Re: State Permit and Decision Document, Boyer Mine, ACT/043/008,  
Folder No. 3, Summit County, Utah

Enclosed is the five-year permanent program mining permit for the Boyer Mine. Two originals are included. Please read the special conditions in Attachment A, then sign both copies and return one to the Division.

Also enclosed is the state's Decision Document, including the Findings, Technical Analysis, and the Cumulative Hydrologic Impact Assessment.

FIGURE 1

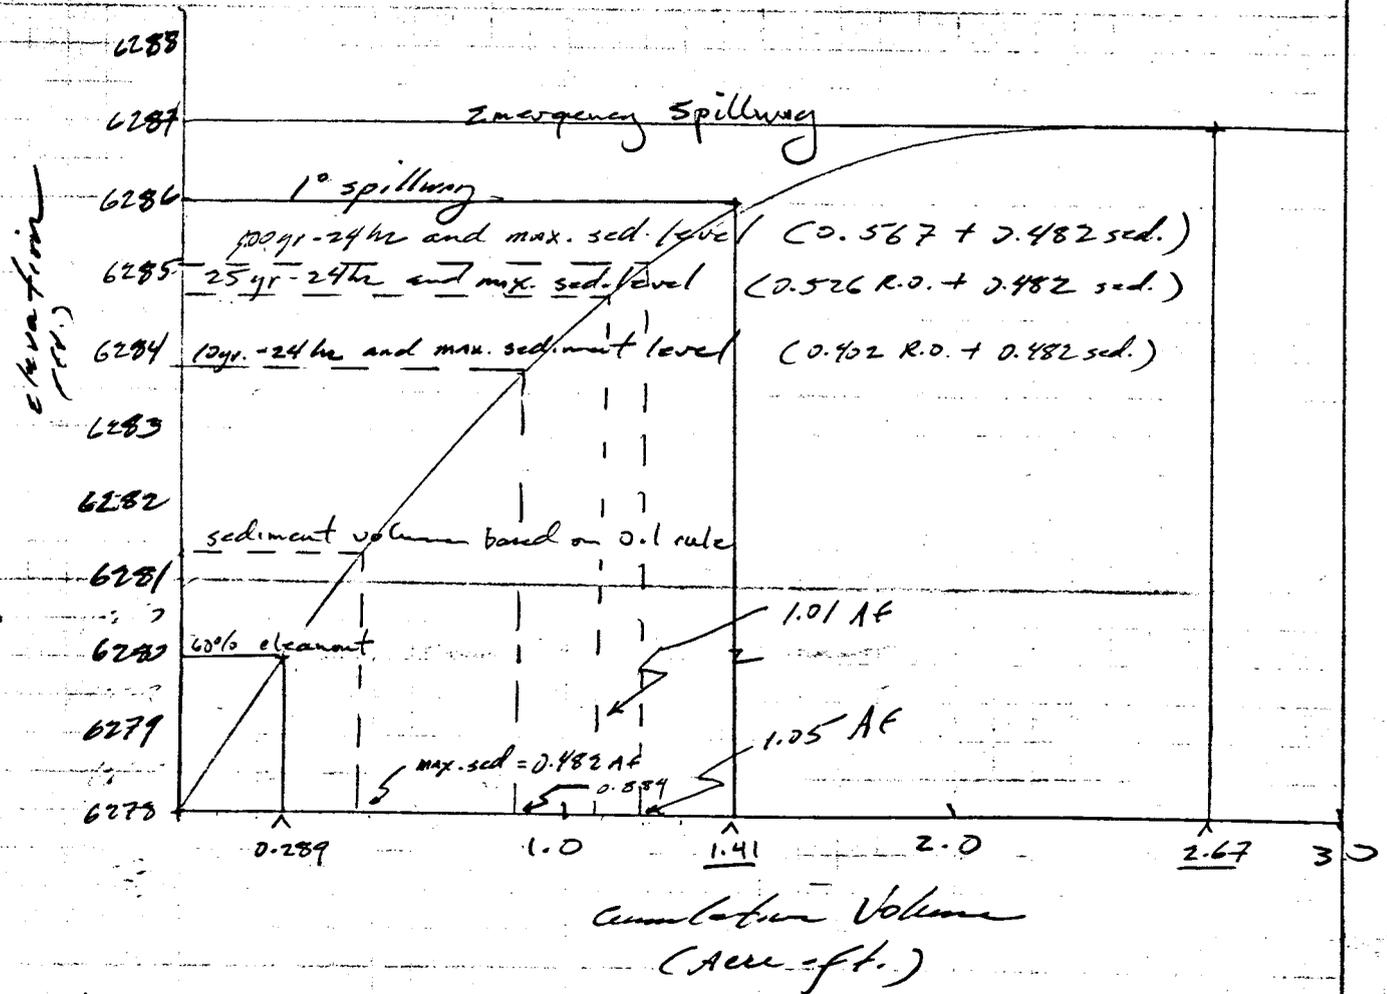
Based upon plate 7-2, the regulatory authority calculated a stage- volume curve for the proposed pond. The curve that is presented in Figure 1 demonstrates that the pond is significantly oversized with respect to ability to contain the runoff volume and required sediment volume from the disturbed area. The volume of the pond is sufficient to contain the 100-yr, 24-hr precipitation event runoff and the design sediment volume at an elevation one foot lower than the primary spillway. UMC 817.46 only requires containment of the expected runoff from the 10-yr, 24-hr precipitation event and design sediment volume.

I. Stage-Volume Curve:

∴ approve all Boyer values are conservative.

FIGURE 2

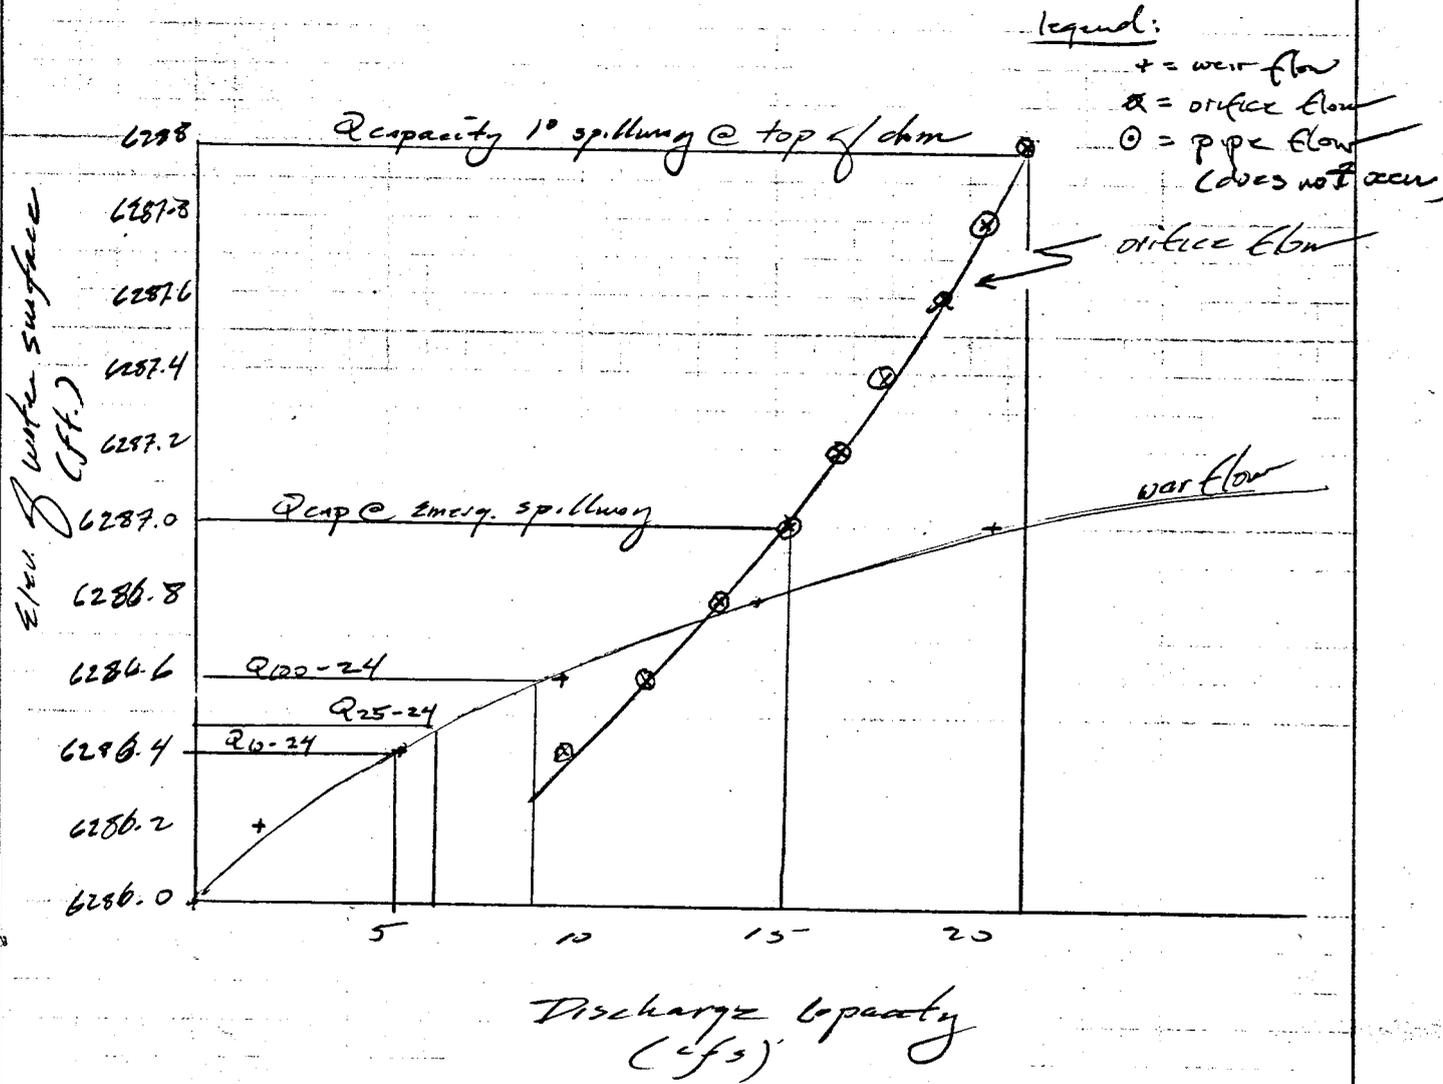
A technical analysis of the spillway system was conducted utilizing hydraulic theory applicable to drop inlet type structures. Values of weir, orifice, and pipe flow were calculated for incremental changes of head of 0.2 feet. The resulting stage - discharge curve is presented as Figure 2. From this curve we can conclude that the spillway is significantly oversized. The primary spillway has the capacity to discharge the 100-yr, 24-hr event (8.77 cfs) at an elevation of 6286.6 ft. which is 0.4 ft. below the elevation of the emergency spillway. Results of the peak flow evaluations can be found in the discussion of UMC 817.43. The applicant's presented values for the peak flow for the disturbed area are in error. Stipulation UMC 817.46-(3)-RPS will correct this deficiency and ensure compliance with this regulation.

II Stage - Discharge Curve:

need add 1' treeboard for 0.3'

3. Within 30 days of permit issuance, the permittee shall provide correct assumptions and peak flow values for design flows used for the design of the sedimentation pond.
4. Within 30 days of permit issuance, the permittee shall submit plans to the Division for the emergency spillway for the sedimentation pond. These plans should incorporate the 25-yr, 24-hr design event, a spillway lining of adequately sized riprap, a filter blanket design, and an adequately sized energy dissipator.
5. Within 30 days of permit issuance, the permittee shall submit to the Division a commitment to inspect the sedimentation pond during construction and submit certified as-built drawings of the structure. These must be conducted by a registered professional engineer.
6. Within 30 days of permit issuance, the permittee shall provide a correct Plate depicting the location of sampling station SS-7.

(2.4")  
C-6  
AWH = 3'  
HW/D = 1.5

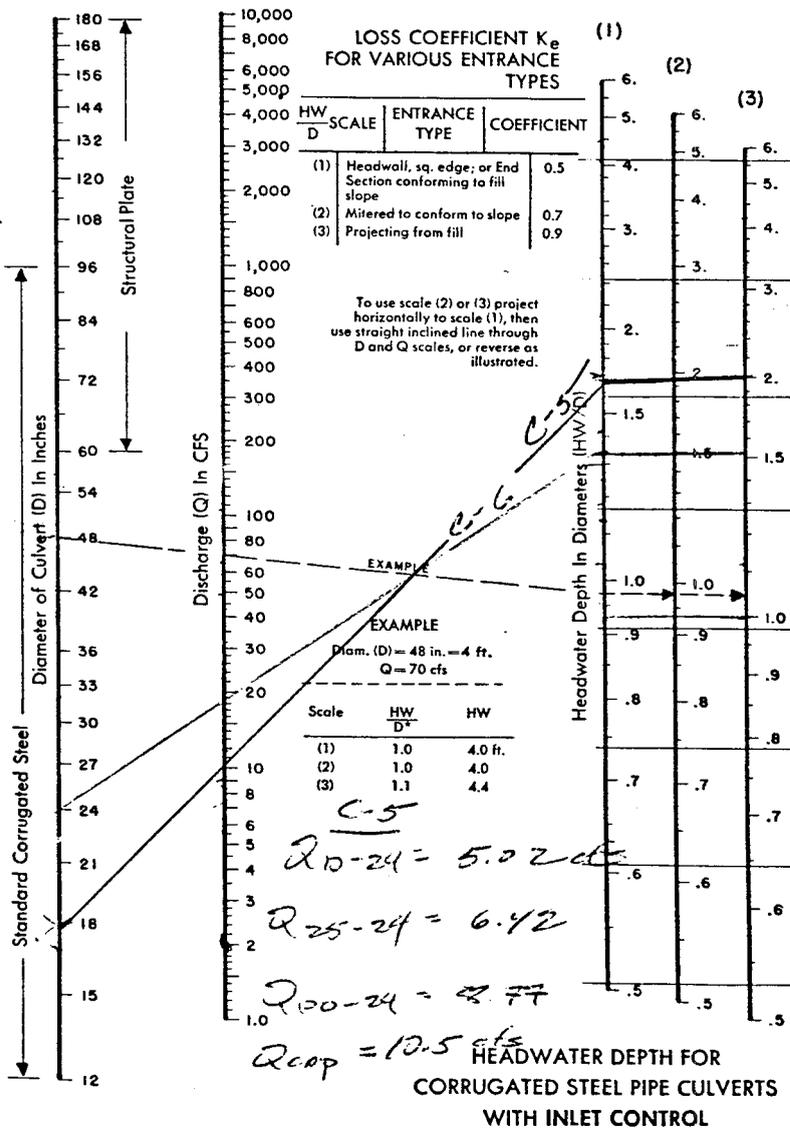
Plate 7-1 depicts the straw bales proposed to treat drainage from culverts C-5 and C-6 as temporary structures. Interpretation of temporary status is questionable. Stipulation UMC 817.42-(2)-RPS will insure the straw bales will be maintained throughout the mining operation and will insure drainage from those treatment structures will comply with effluent limitations.

2. The permittee shall within 30 days of permit issuance, submit revised appropriate sections and plates in the MRP to reflect a commitment to retain straw bale (or equivalent) treatment structures at the outlet of culvert C-6. Additionally, the permittee must commit, within 30 days of permit issuance, to sample all discharges from these structures and incorporate the analysis schedule proposed in Table 5-1 for all samples. A commitment to submit results of the analysis to the Division within 30 days of receipt must also be made.
